Product Management Bulletin

Number: 000-759

Product Notice: Change to AccuTouch® Resistive Touch Screen Protective Liner

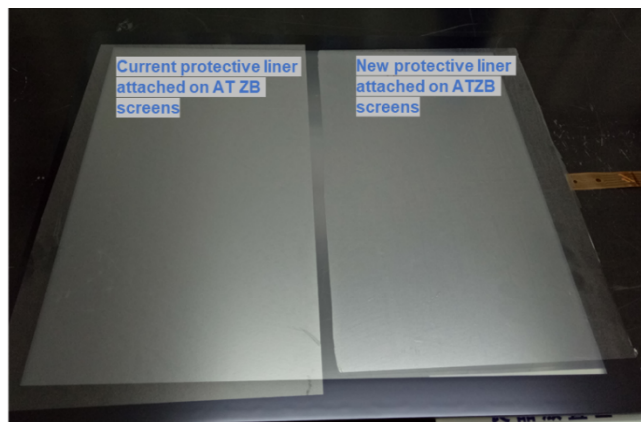
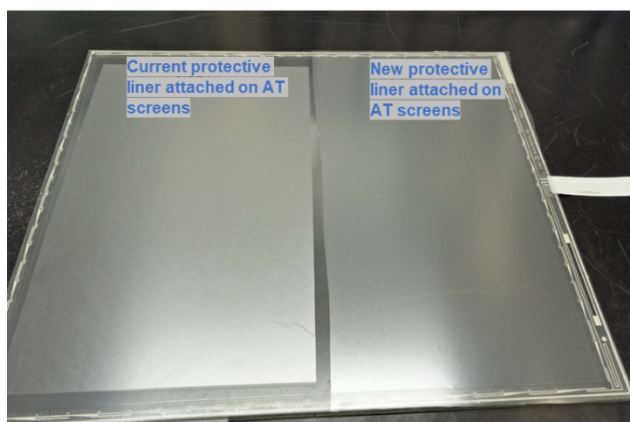
Due to material shortages in the market, a change to the protective liner used on Elo's AccuTouch® Resistive touch screens is required. The protective liner is attached to the coversheet of the AccuTouch screen after the touch screens are built. It is used to protect the screen during shipment and is removed once integrated into the final assembly.

While we make every effort to minimize product changes, at times the market may dictate that Elo has to make changes in material sources to ensure continued supply. Elo has completed extensive testing on this new protective liner and there is no impact to function or form factor of the product. We will implement this with a revision change.
